**STAFF RECOMMENDATION**  
**1826 Wildwood Avenue (1817 Rosewood Avenue)**  
**February 15, 2017**

**Application:** New construction-infill  
**District:** Belmont-Hillsboro Neighborhood Conservation Zoning Overlay  
**Council District:** 18  
**Map and Parcel Number:** 11704013200  
**Applicant:** Preston Quirk, Quirk Designs  
**Project Lead:** Melissa Sajid, [Melissa.sajid@nashville.gov](mailto:Melissa.sajid@nashville.gov)

**Description of Project:** The applicant proposes to construct a new single-family home on the rear of the lot, facing Rosewood Avenue.

Figure 4: Height of new construction in relation to historic house at 1826 Wildwood Avenue

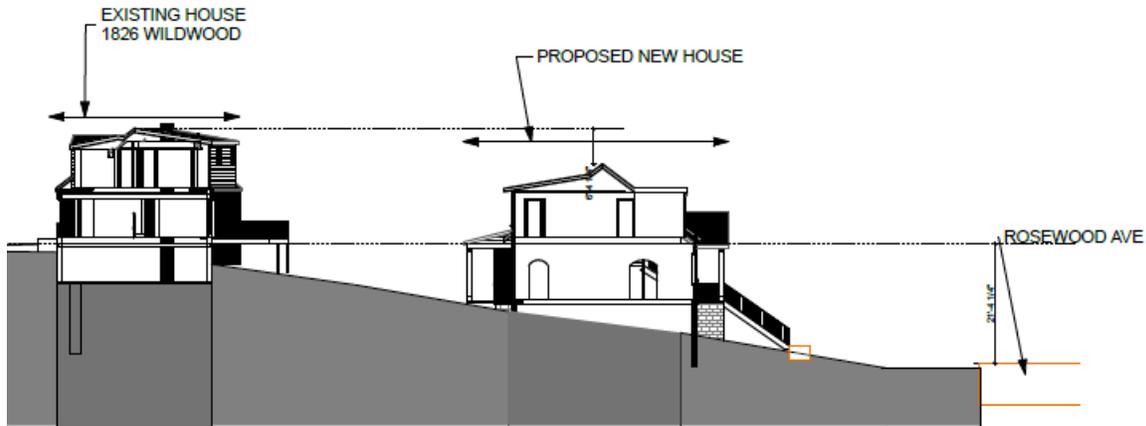
The proposed infill is one and one-half (1.5) stories at the front with an overall height of thirty-one feet, seven and one-half inches (31'-7 1/2") and a foundation height of six feet, seven inches (6'-7"), measured from grade. Staff finds that the overall height and foundation height proposed are appropriate in this case as it is comparable to the two existing homes located to the left of the site and will not be taller than the historic house at 1826 Wildwood Avenue when taking into account the change in grade on the site (Figure 4).

SITE SECTION

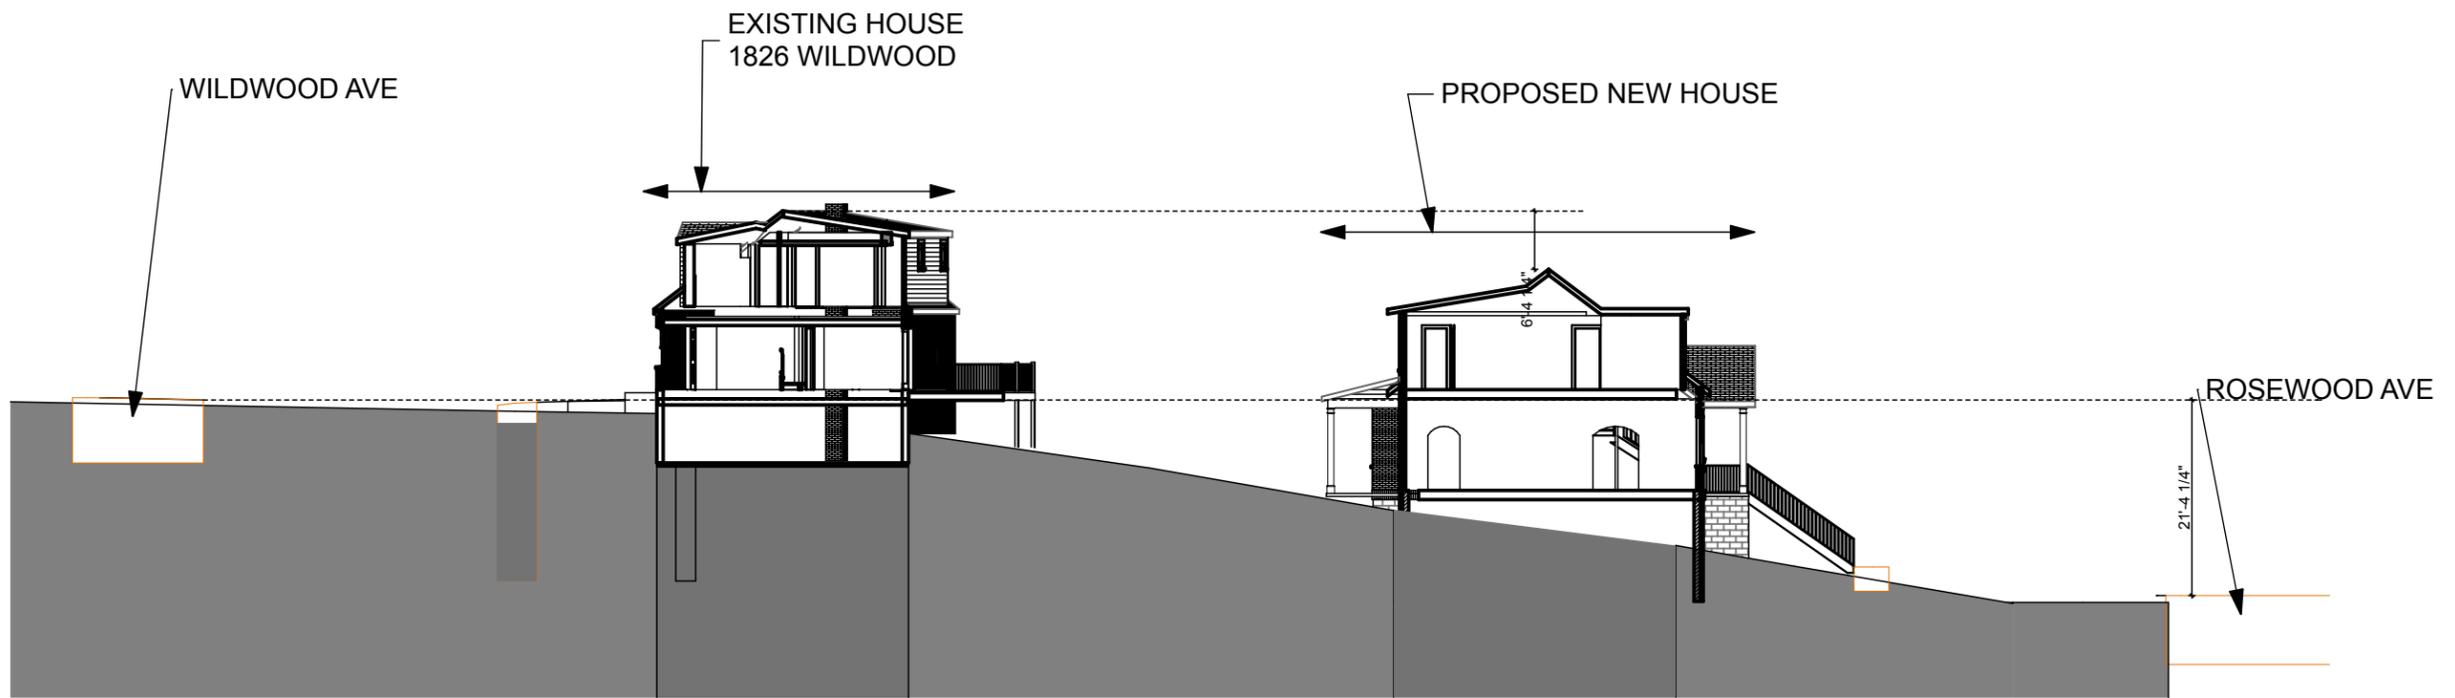
Staff finds that the new construction's height and scale are appropriate in this case as they are oriented to a street that is outside of the overlay that has no historic context and will have no impact on the historic house oriented to Wildwood Avenue given the significant change in grade across the site. For these reasons, staff finds that the project meets sections II.B.1.a. and b.

SIDE ELEVATIONS

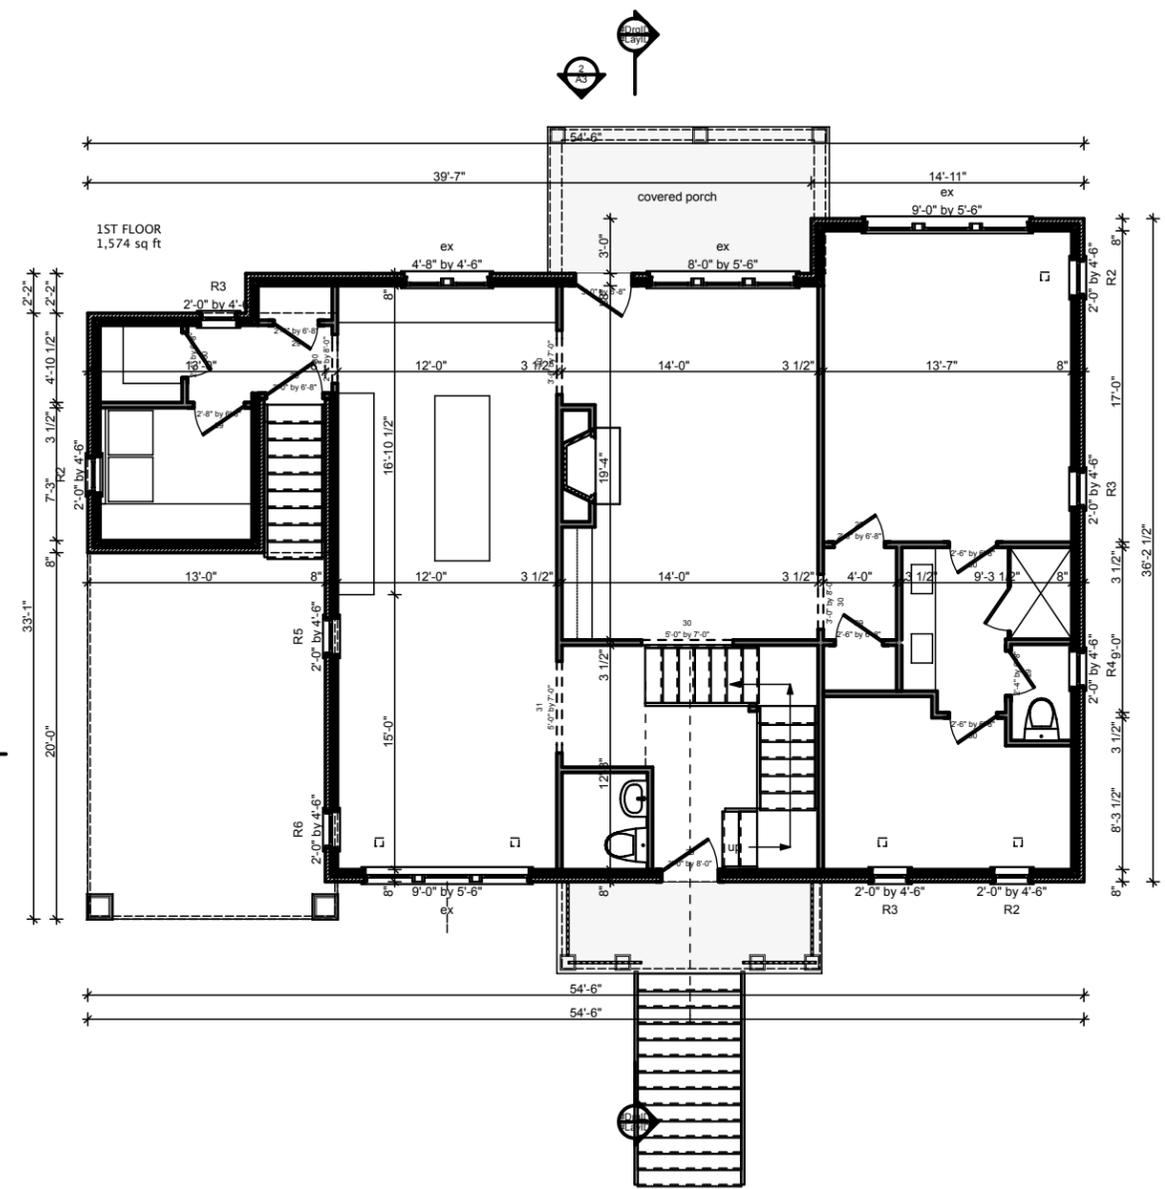
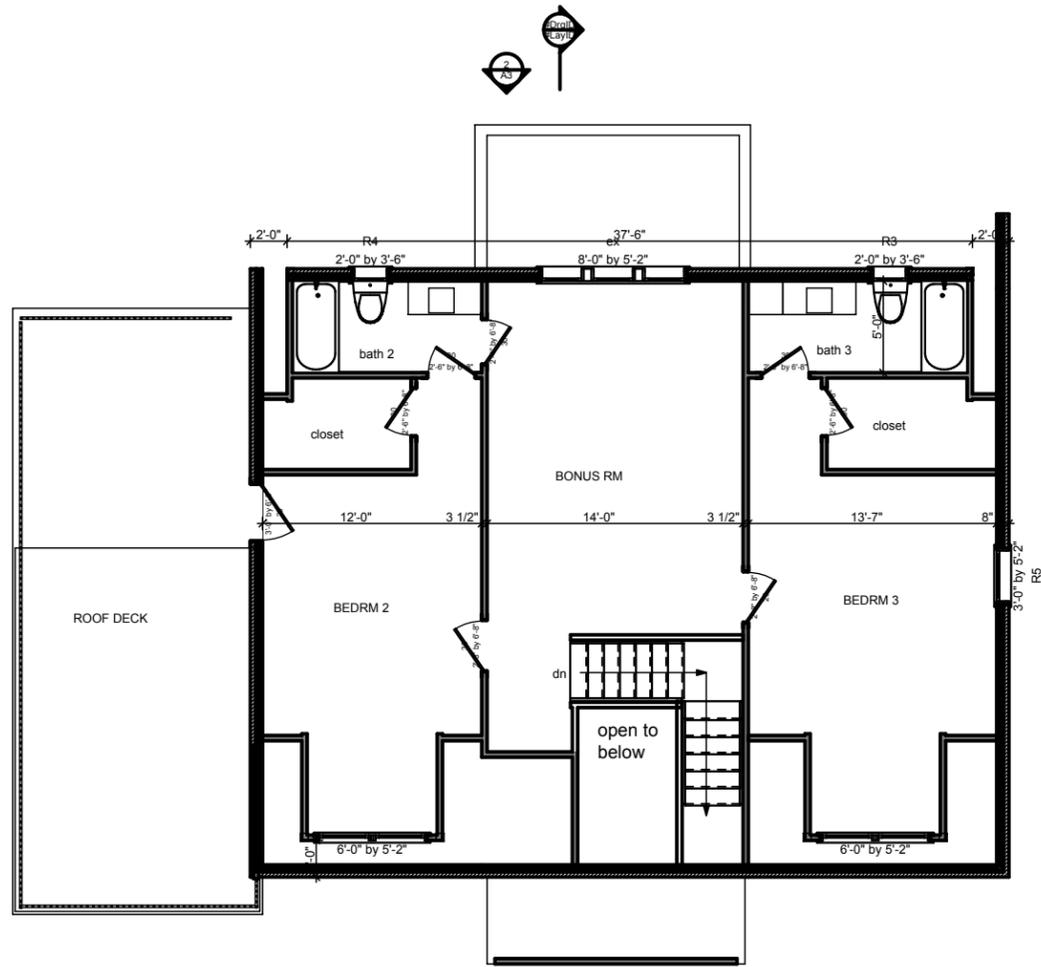
Proportion and Rhythm of Openings: Most of the windows on the new construction are generally twice as tall as they are wide, thereby meeting the historic proportions of openings. There is one rectangular casement window at basement level on the right façade. Staff finds that this window is appropriate as it is at basement level and will not be visible from properties located in the Belmont-Hillsboro Neighborhood Conservation Zoning Overlay. There are no large expanses of wall space without a window or door opening. Staff finds the project's proportion and rhythm of openings to meet Section II.B.1.g.

Appurtenances & Utilities: The new construction will have a walkway leading from the front porch to the driveway and a driveway/parking pad will be located off Rosewood Avenue, which is typical of homes on this block. The location of the HVAC and other utilities was not noted. Staff asks that the HVAC be located on the rear façade or on a side façade beyond the midpoint of the house to ensure that the project meets section II.B.1.h. of the design guidelines.

1. The finished floor height shall be consistent with the finished floor heights of the adjacent historic houses, to be verified by MHZC staff in the field;
2. Staff approve the final details, dimensions and materials of roof color, porch floors, trim, driveway and walkway material, windows, and doors prior to purchase and installation;
3. The HVAC shall be located behind the house or on either side, beyond the mid-point of the house; and
4. Staff approve the masonry color, dimensions and texture.
